This is to reply to your email correspondence reference number 14801, 731 reference number EA96680, FCC ID OEUPA882M180WS2

PA BLOCK DIAGRAM

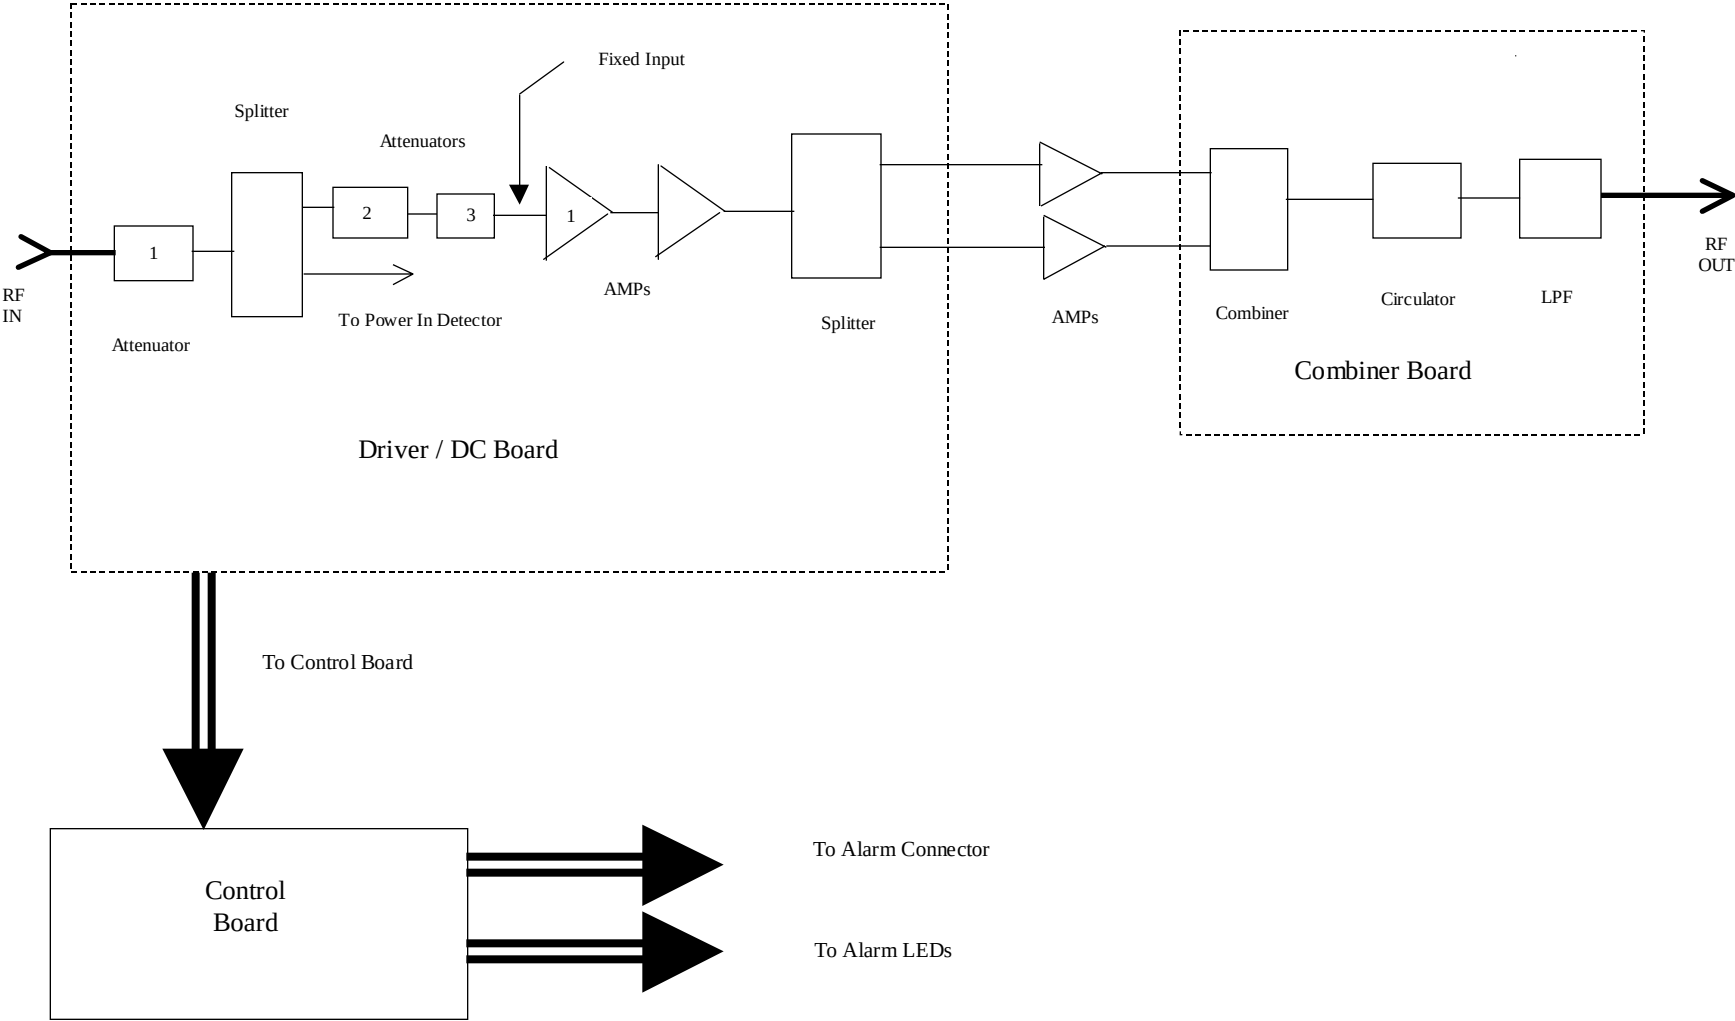
1. We are requesting that the spurious, radiated, conducted and occupied bandwidth tests at 20W input to be waived due to the fact that the PA is designed so that the input RF level to the driver gain stage always remains constant. In other words, the PA's overall RF characteristic will not change with the input level's variation.

As show in block diagram below, the variable RF signal at the PA input is always padded down to a fixed level before feeding to AMP1. This is done using a combination of resistive attenuator (1), voltage variable attenuator (2) and resistive network attenuator (3). The resistive attenuator (1) is varied from 5, 10, 15 or 20dB depending on the customer's input level. The voltage variable attenuator (2), which controlled by the microprocessor, is then used to fine tune the RF signal to a fixed level expected at AMP1 input. The result is the same RF signal will be passing through the entire gain lineup every time, independence of the PA input.
